PCD File No. PPR-21-

SADDLEHORN RANCH
 OVERALL WATER SYSTEM
 GRADING & EROSION CONTROL PLAN

**SUBSURFACE SOIL INVESTIGATION
WATER STORAGE TANK AND
TREATMENT FACILITY
SADDLEHORN RANCH SUBDIVISION
EL PASO COUNTY, COLORADO**

C12
 SHEET 12 OF ---

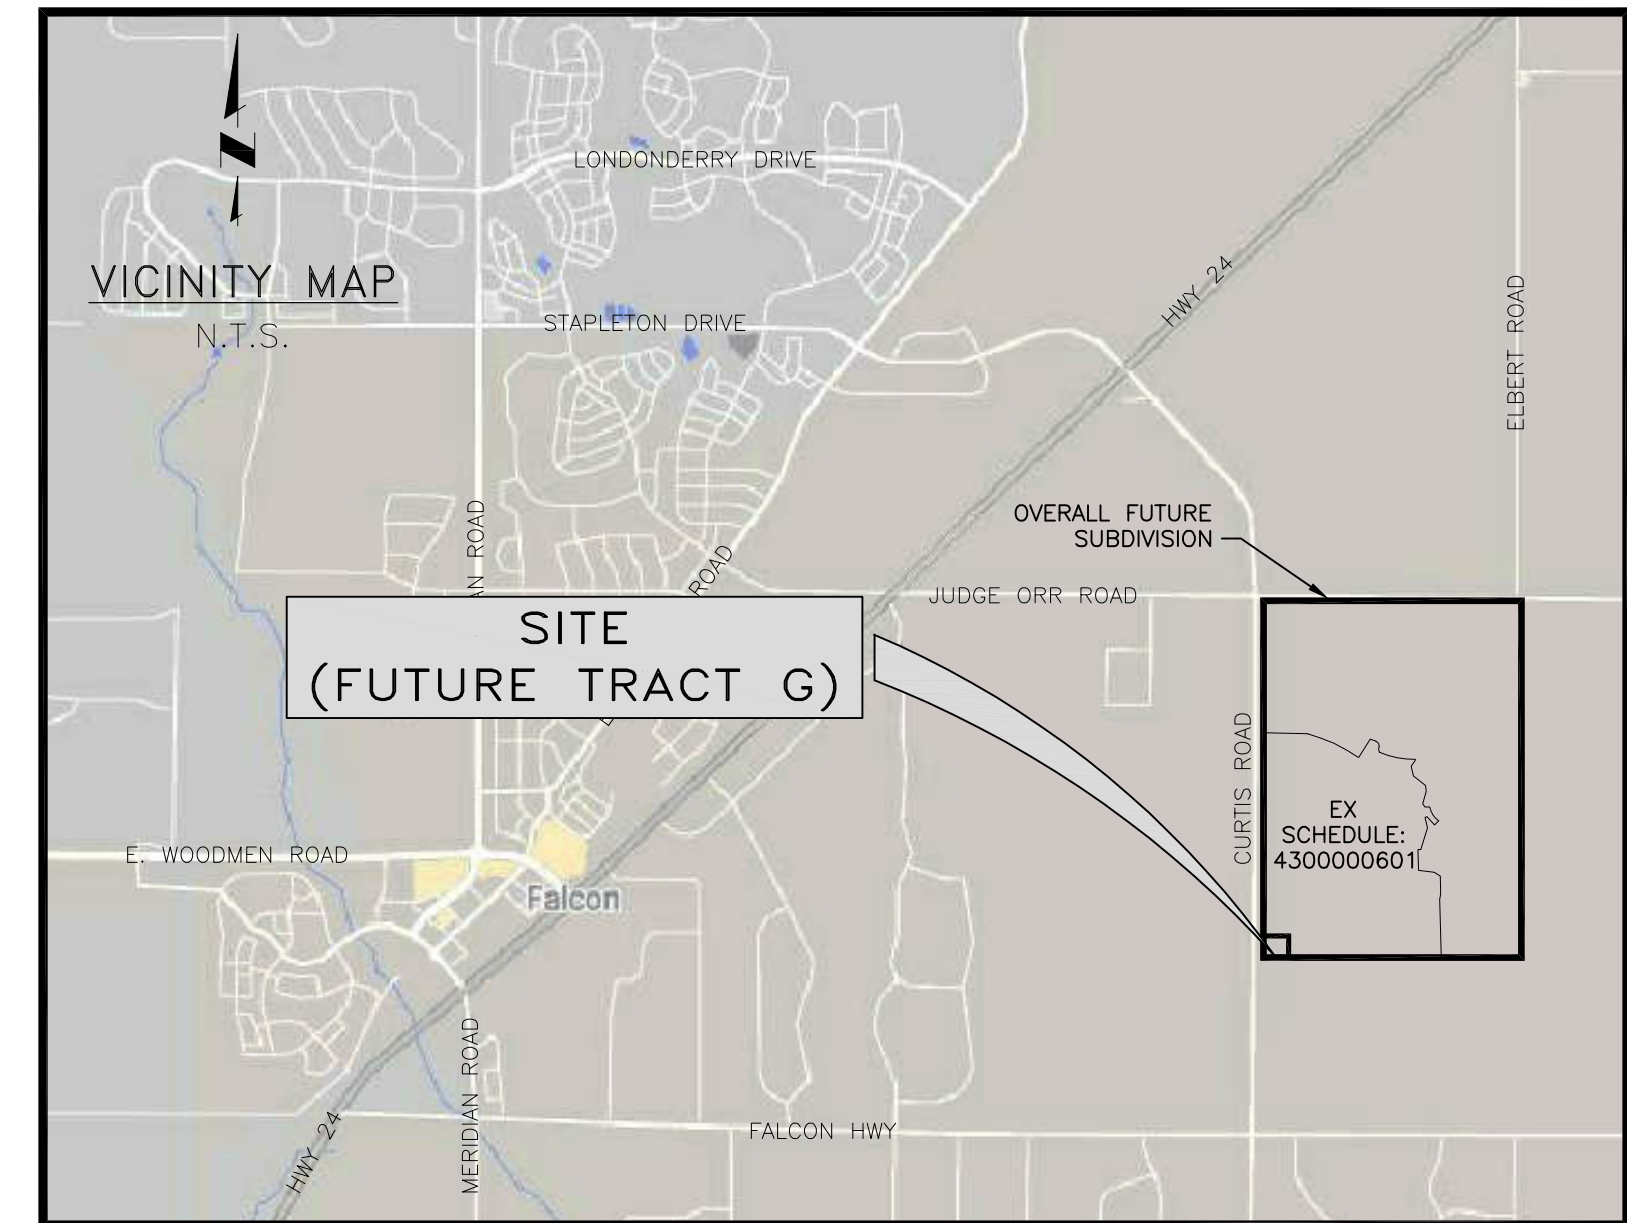
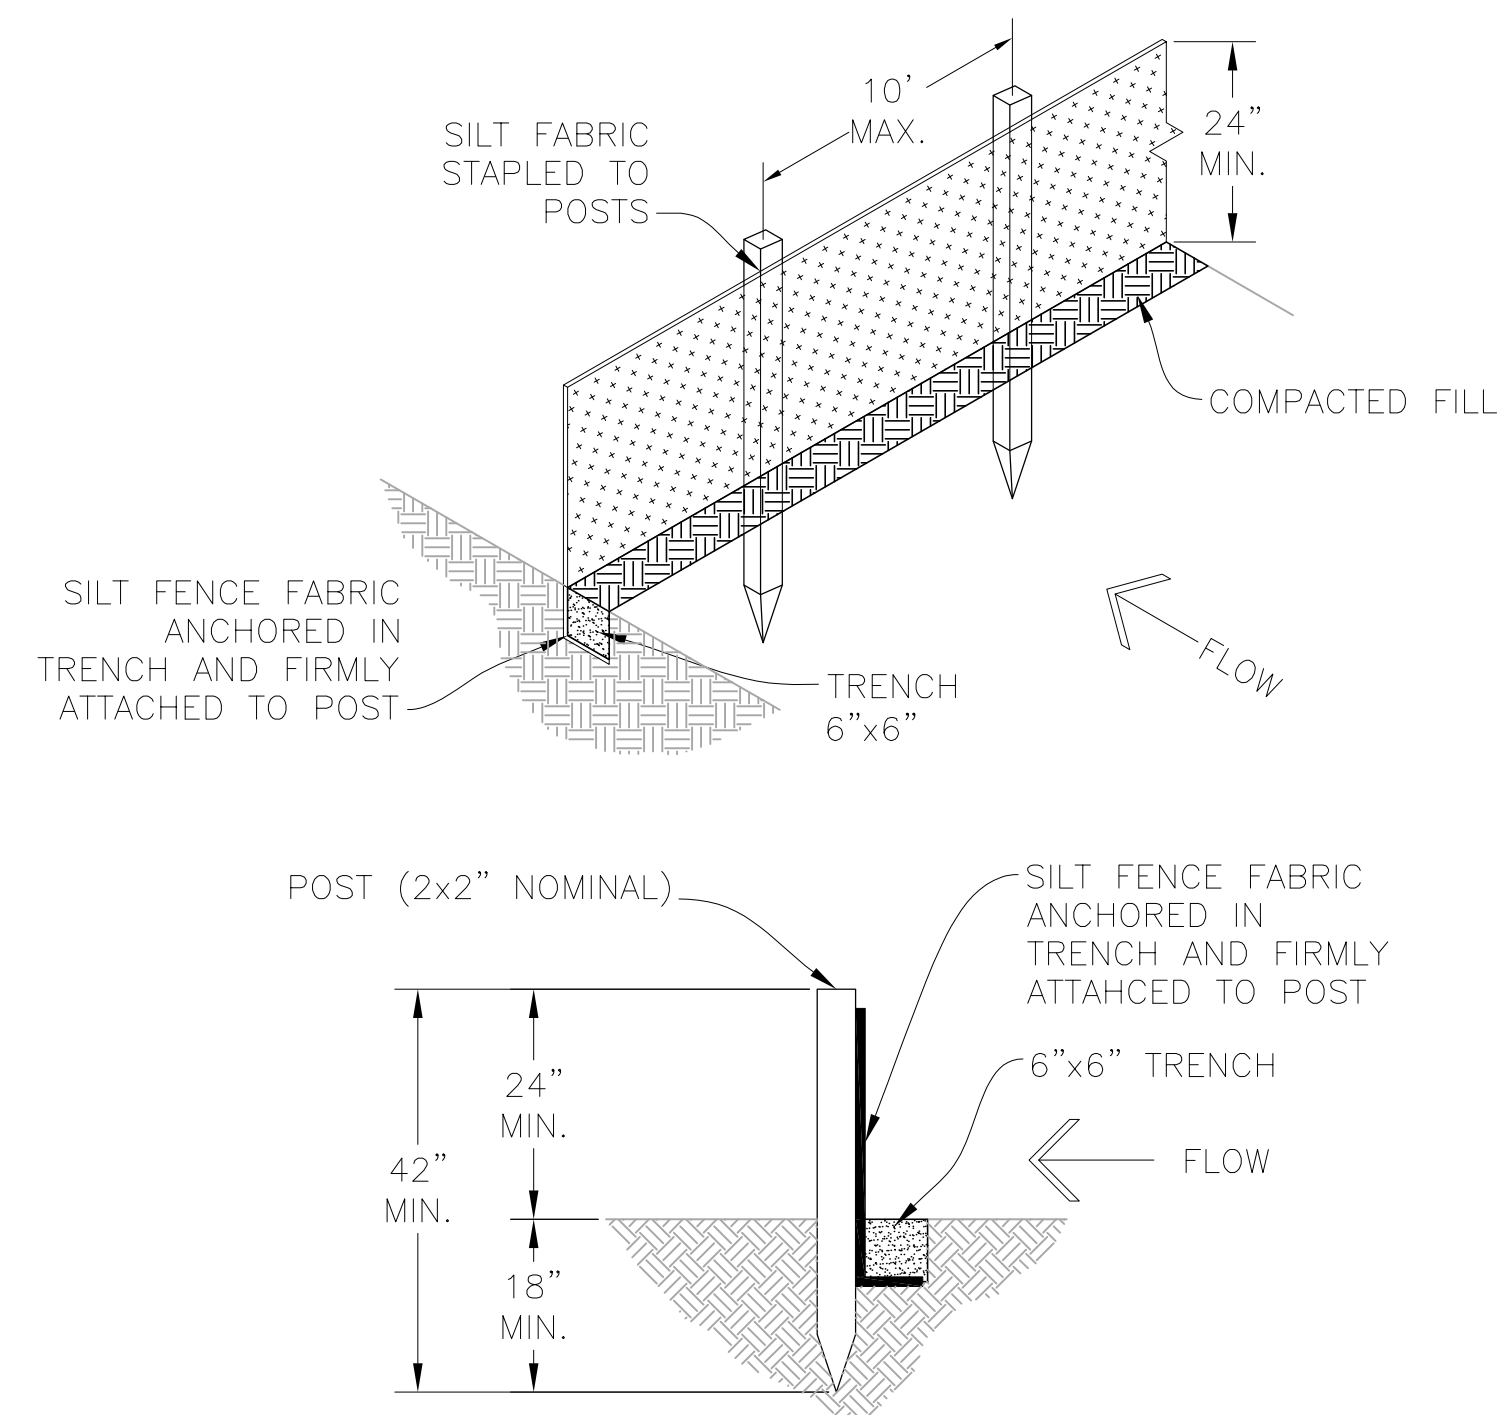
Show/callout J-hooks in areas where silt fence is installed perpendicular to contours to slow down concentrated flow.

Checklist Item "j" - make a note about FEMA 100-yr floodplain (ex: not within site boundaries).

C15

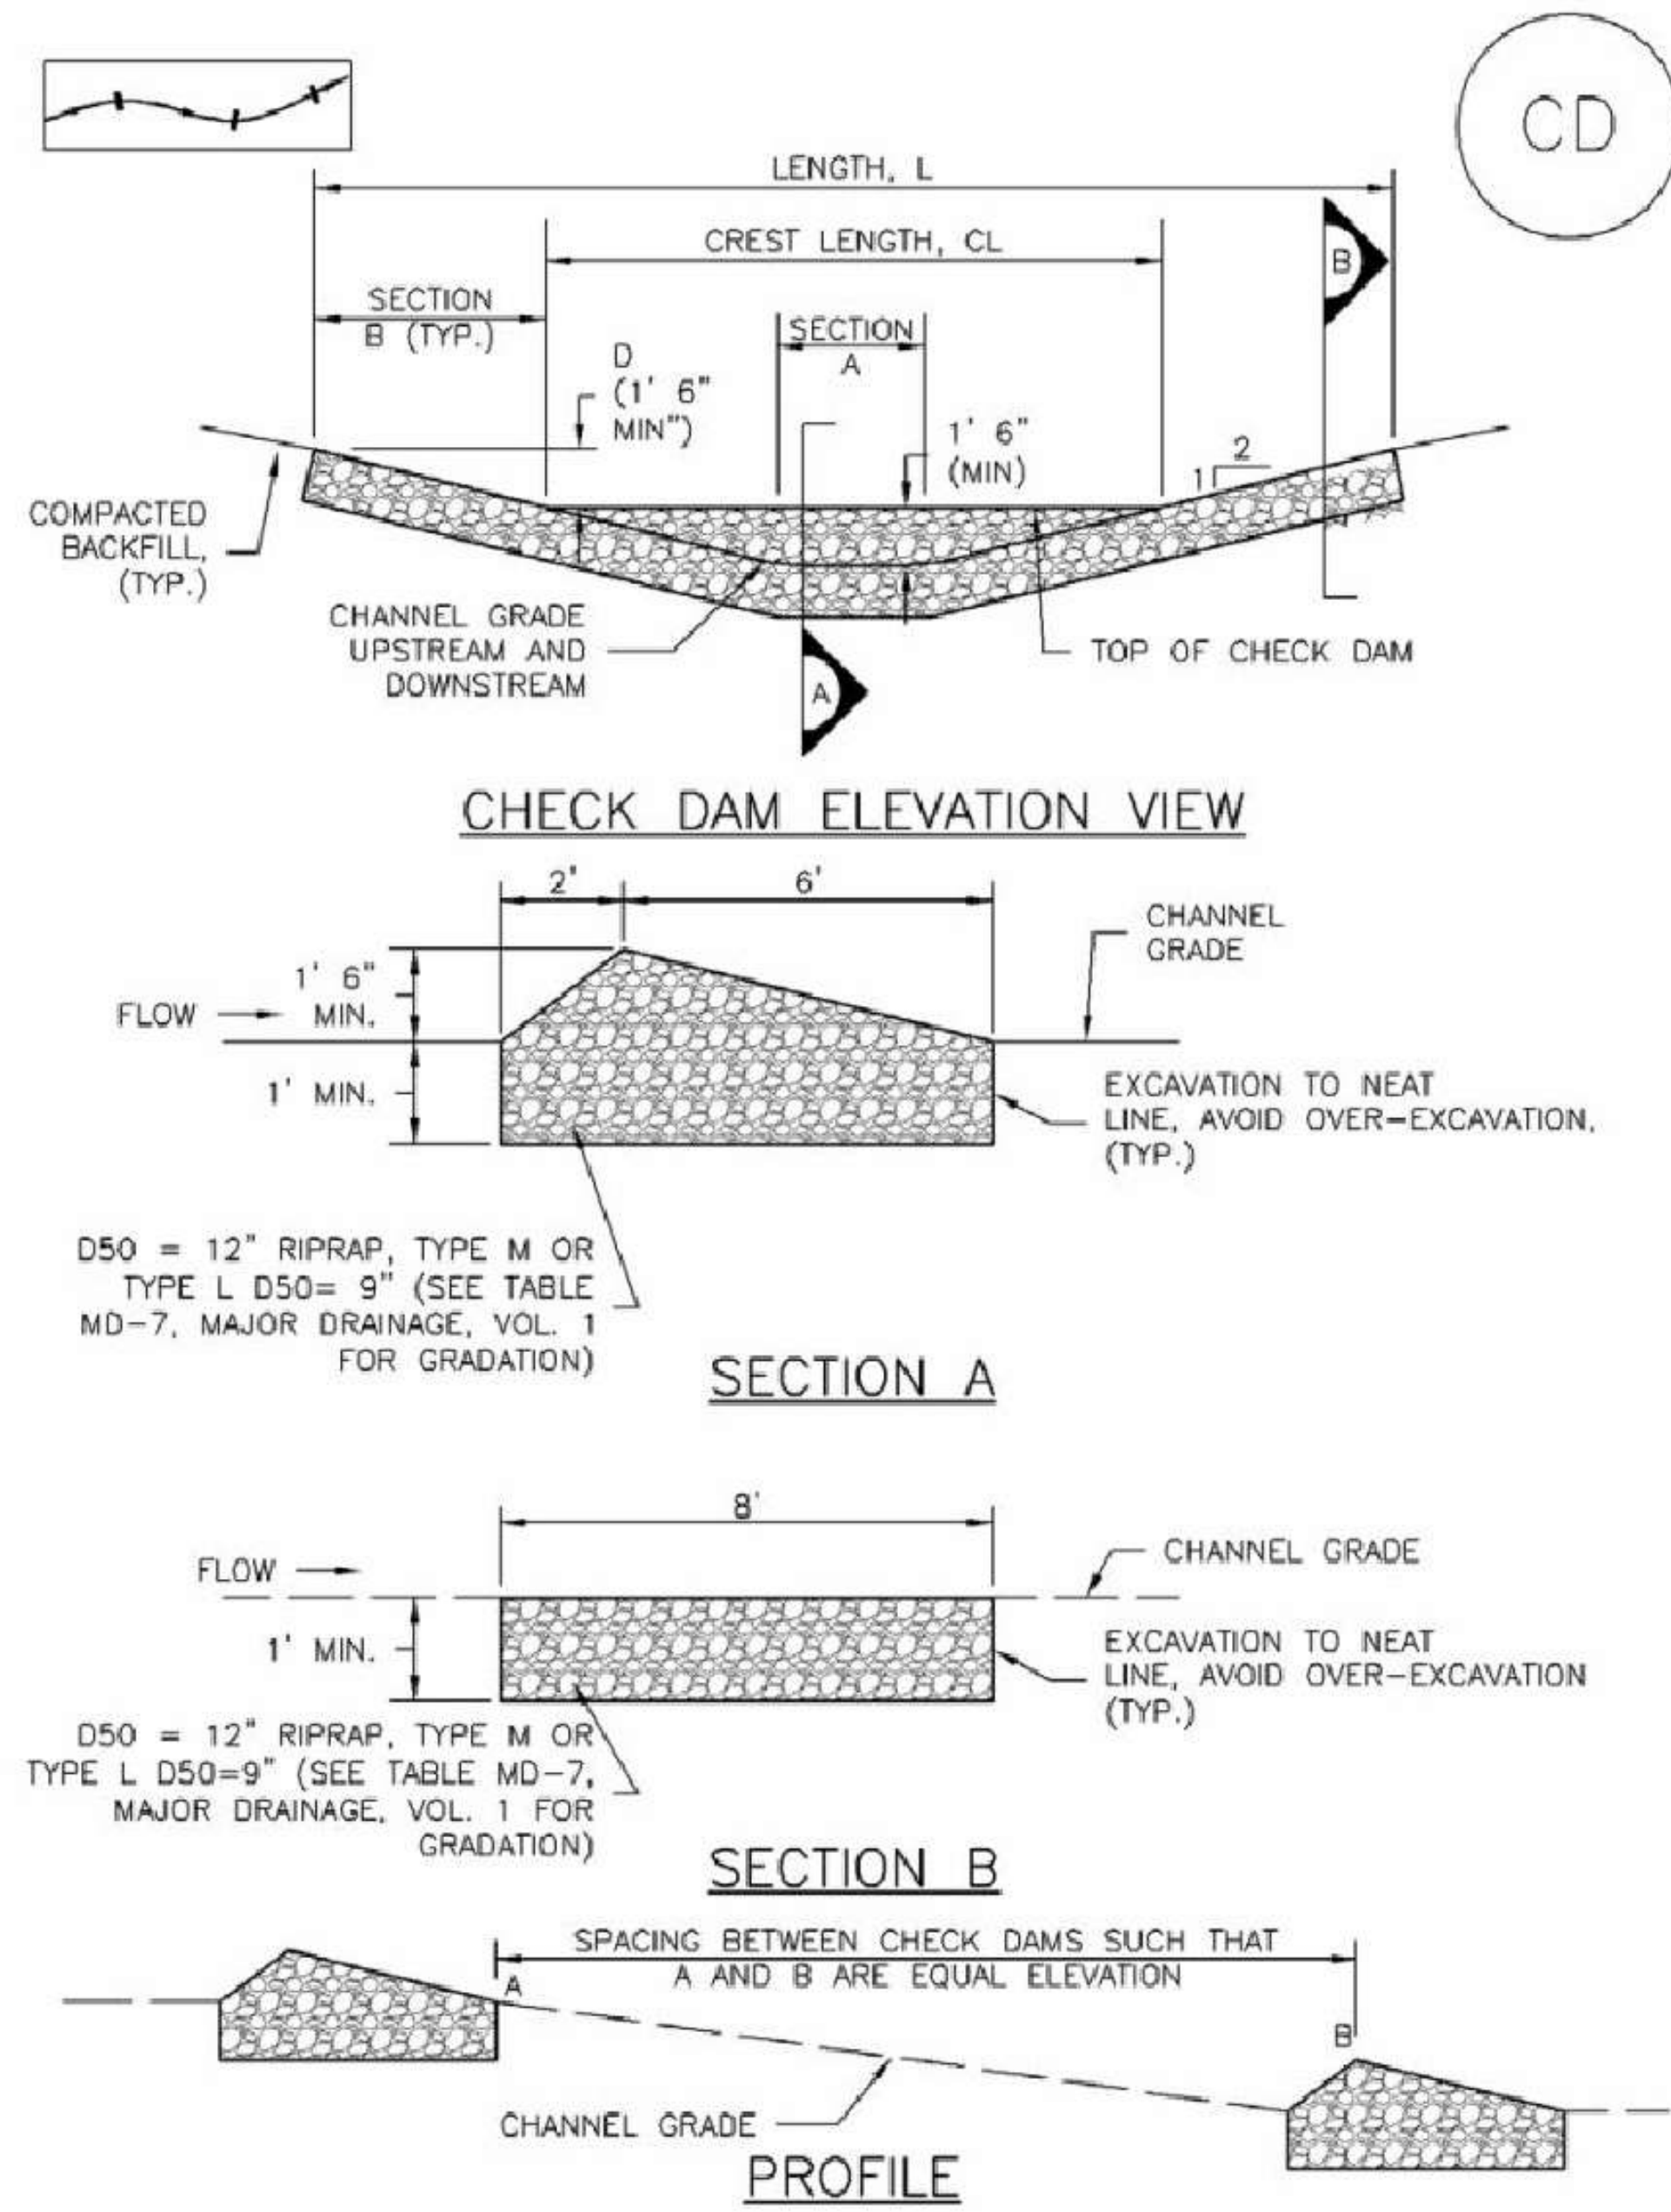
Include details for the following BMP's. Examples of acceptable details for each are provided:

BMP	Detail # and Source			
	ECM (Appendix F)	DCM (Vol 2: Chap 3.3)	MHFD (USDCM Vol 3: Chap 7)	CDOT Standard Plans on M-208
Mulching		MU-1	EC-4	1
Seeding		TS-1	EC-2	
Stabilized Staging Area			SM-6
